Ms. Tricia L. DeBleeckere
Minnesota Public Utilities Commission
121 7th Place East STE 350, St. Paul, MN 55101

RE: Big Blue's Post Construction Noise Analysis and Report by WSB false fabricated results

This is WSB's report showing the M2 was recording while lying in the ditch.

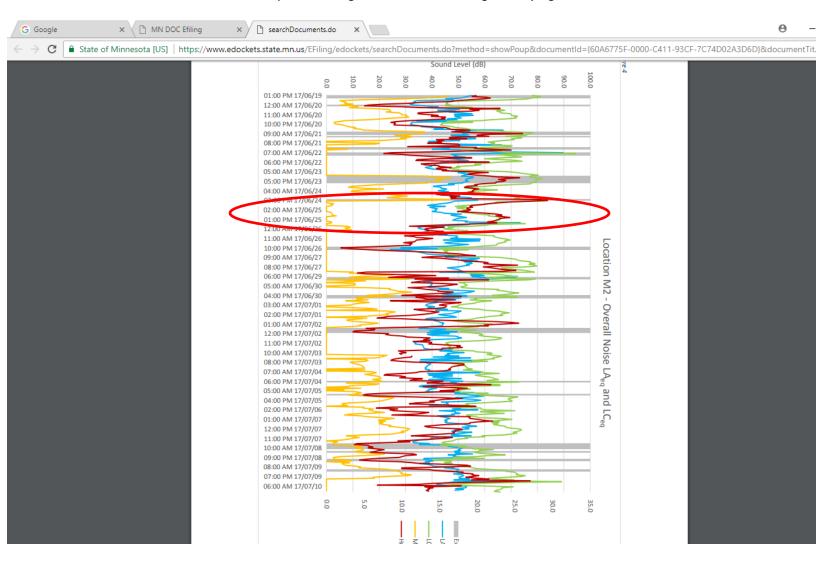
The most important false fabrication happened on June 24th and June 25th. The microphone that was on the flimsy tripod tipped over and was lying in the ditch upside down. I took a picture of the microphone laying in the ditch at 5:20 pm on June 25th. However, the results from the WSB study shows this same microphone that was lying in the ditch was recording sound levels. As a matter of fact they say the LAeq was 70 db at the very same time the microphone was laying down on the ground in the grassy road ditch. I then contacted Charlie to tell him his microphone was lying in the ditch, he went out and straighten it up later that day or the next day; I didn't see him fix it.

WSB says on page 9 of their report that the M2 has a measurement gap on June 28th through June 29th. This may be true because the tripods were flimsy unprofessional and cheap, but also the microphone was laying in the ditch on June 24th and 25th. I believe all of the WSB results should be discarded as false and unusable.

I believe WSB fabricated the results of the Post Construction Noise Analysis Report for Big Blue to fit their client's needs. This is another blatant disregard of the Commission's rules, therefore Big Blue needs to be suspended or the site permit revoked.
